Subject: Response to Comments - Initial Study/Mitigated Negative Declaration
Red Dirt Grapes LLC., Vneyard Conversion
Agricultural Erosion Control Plan File #P22-00143-ECPA
approximately 0.3 mile east of the terminus of Long Ranch Road
APN 032-030-071^{SFAP} with 032-560-038^{SFAP}
SCH #2024030142

RE: Response to Comments – Red Dirt Grapes LLC., Vineyard Conversion
Agricultural Erosion Control Plan (ECPA) #P22-00143-ECPA
Assessor’s Parcel Numbers 032-030-071^{SFAP} with 032-560-038^{SFAP}
SCH #2024030142

This memorandum for the Red Dirt Grapes LLC., Vineyard Conversion Agricultural Erosion Control Plan #P22-00143-ECPA Proposed IS/MND, presents the name of the persons and organizations commenting on the Proposed IS/MND and responses to the received comments. This memorandum, in combination with the Proposed IS/MND, completes the Final IS/MND.

Exhibit 1

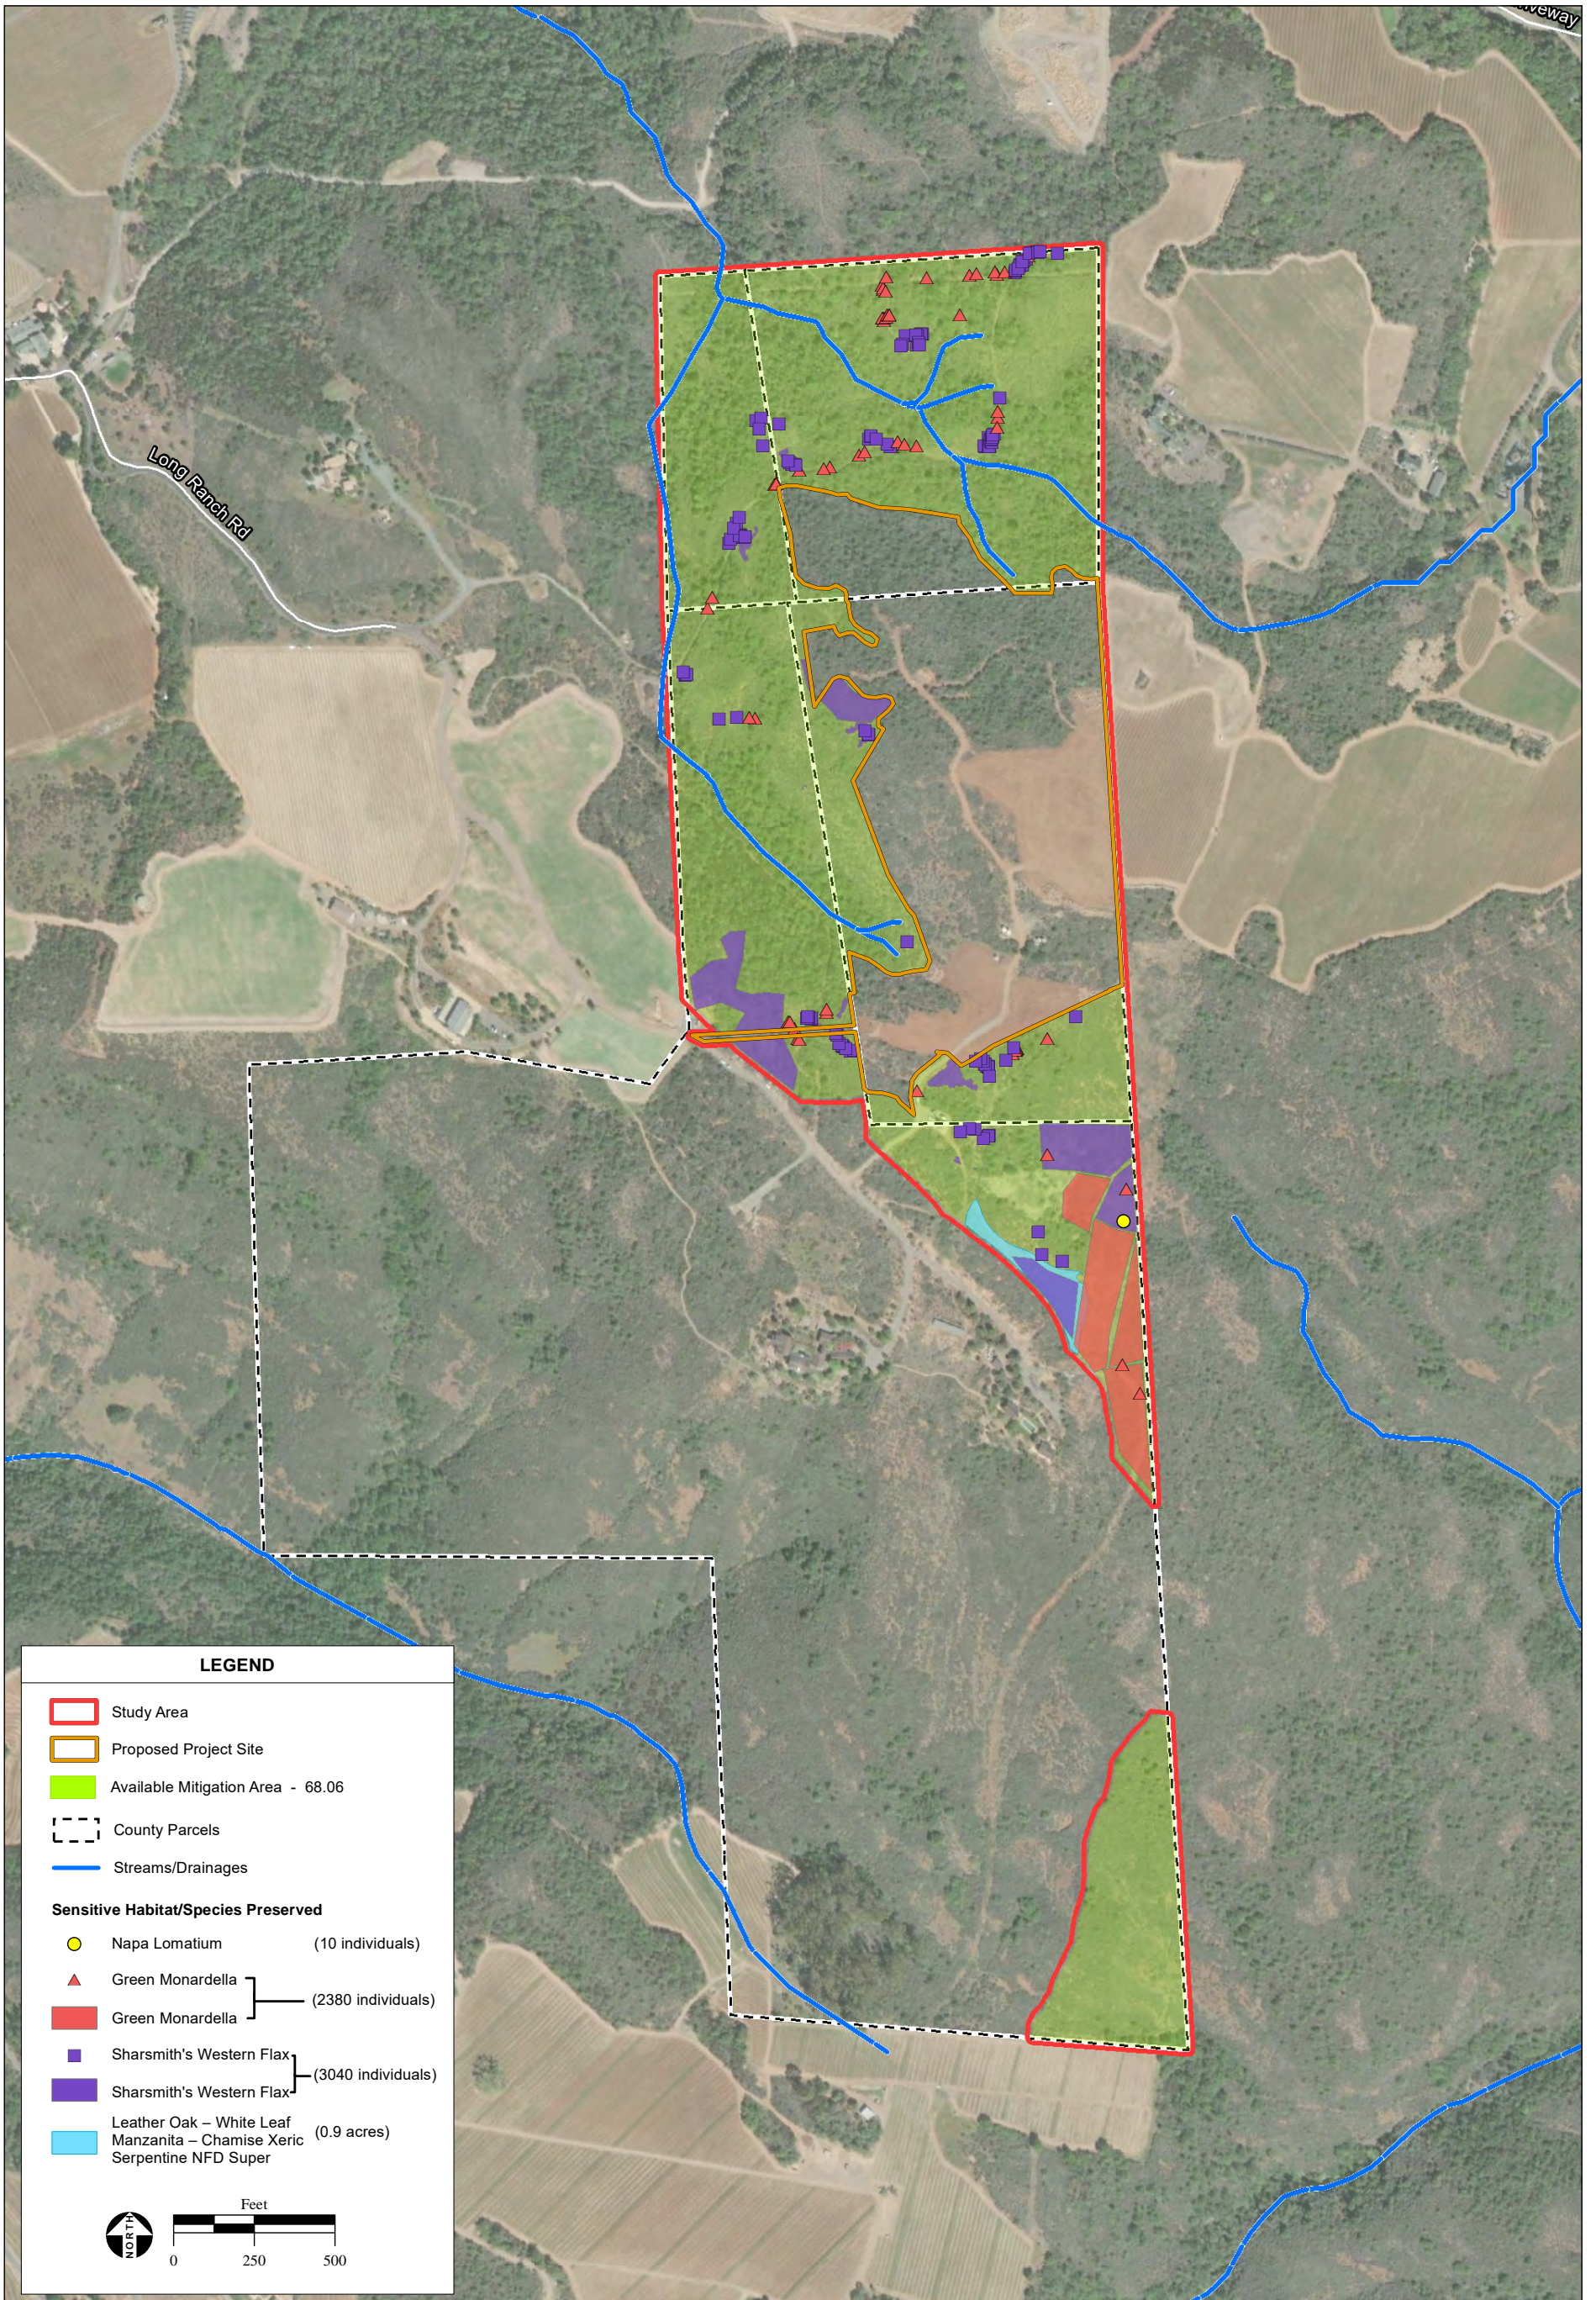
Regarding Figure 4 (Mitigated Area) and the overall Preservation Area, as indicated in the Environmental Commitments Section of the Proposed IS/MND (page 2, paragraph 1), the project as proposed includes up to a 68.06-acre mitigation area for the retention and preservation of special-status plant species and associated habitat is included in the project (Figure 8 of **Exhibit B-1** of the Proposed IS/MND: Attached as **Exhibit 1**). As indicated above, the area removed via mitigation would be added to the Preservation Area resulting in an approximate 70.5-acre Preservation Area. However, based on mapping and calculations prepared by the project engineer (Mike Muelrath, RPE #67435, of Applied Civil Engineering Inc.) in preparing the Final Mitigated ECPA Plans, has identified the Project's proposed Preservation Area in conjunction with the area added through mitigation results in an approximate 68.1-acre Preservation Area.

Furthermore, all areas shown in the Project's Preservation Area Figure, including the area removed by mitigation, will be preserved, regardless of the acreages identified through mapping prepared by the Project's Biologist (Montrose Environmental). Attached as **Exhibit 2** is the 'Mitigated Preservation Area' which shows that the extent of the Preservation Area is consistent with what was disclosed and analyzed in the Proposed IS/MND.

EXHIBIT "2"

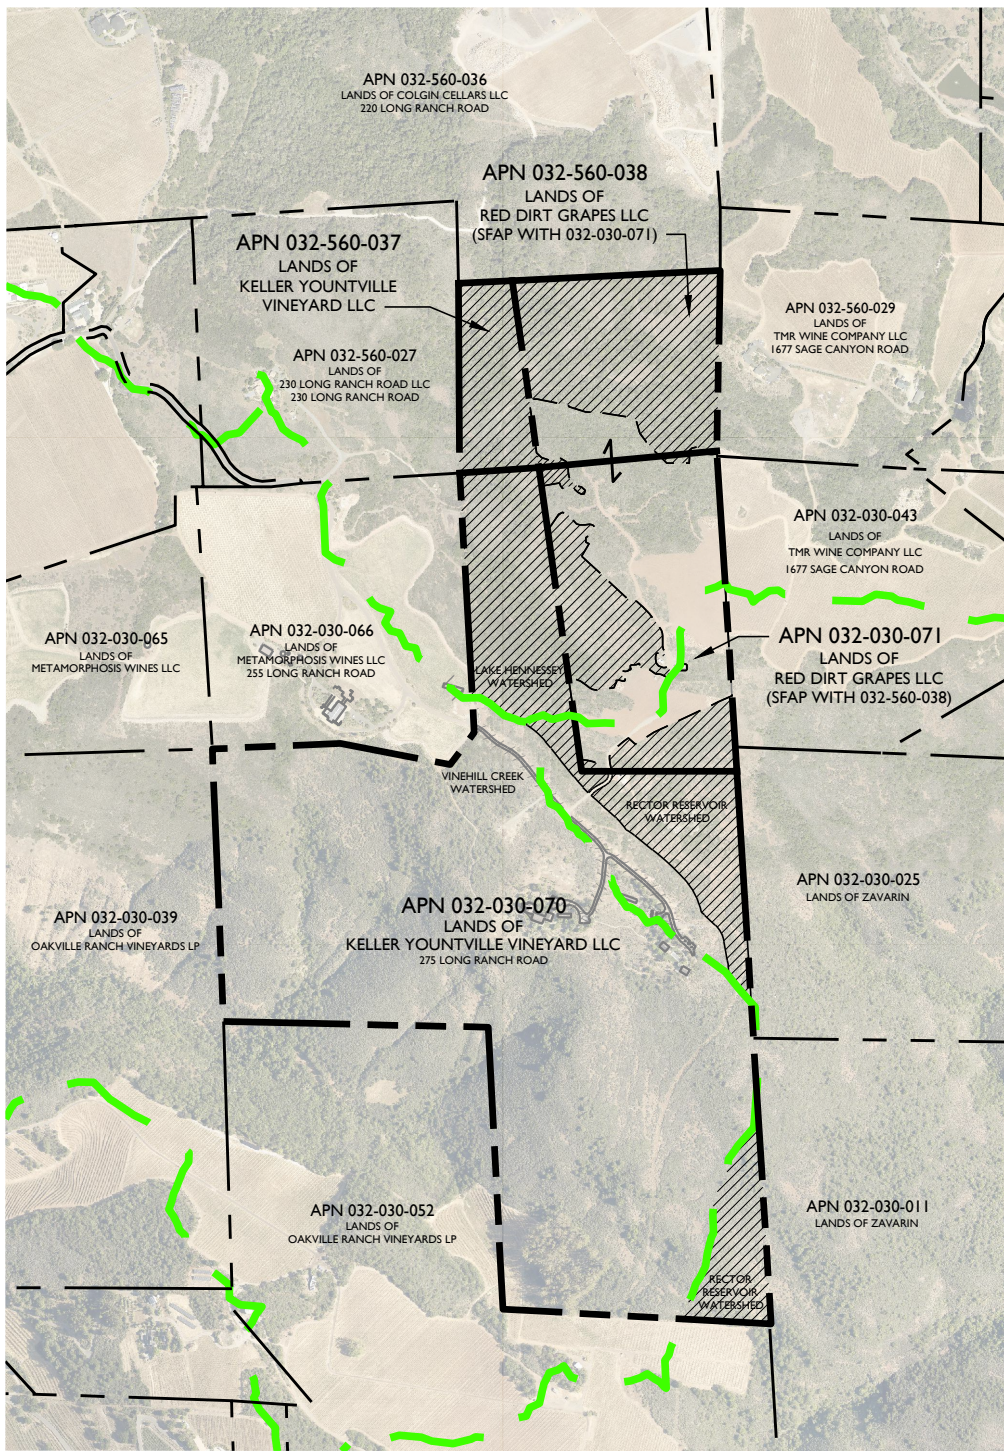
Because the Project's Mitigated Preservation Area (**Exhibit 2**) and associated acreage has been corroborated by the Project Engineer (Applied Civil Engineering) the County has determined this minor discrepancy does not affect the overall intent or coverage of the Preservation Area, and it does not result in any new potentially significant impacts, or that additional mitigation measures must be added to reduce impacts to a less than significant level, and none of the grounds for recirculation of the Proposed IS/MND as specified in State CEQA Guidelines Section 15073.5 have been identified. As such **Mitigation Measure BIO-1.c** will identify the minimum acres of Preservation Area as confirmed by the Project Engineer.
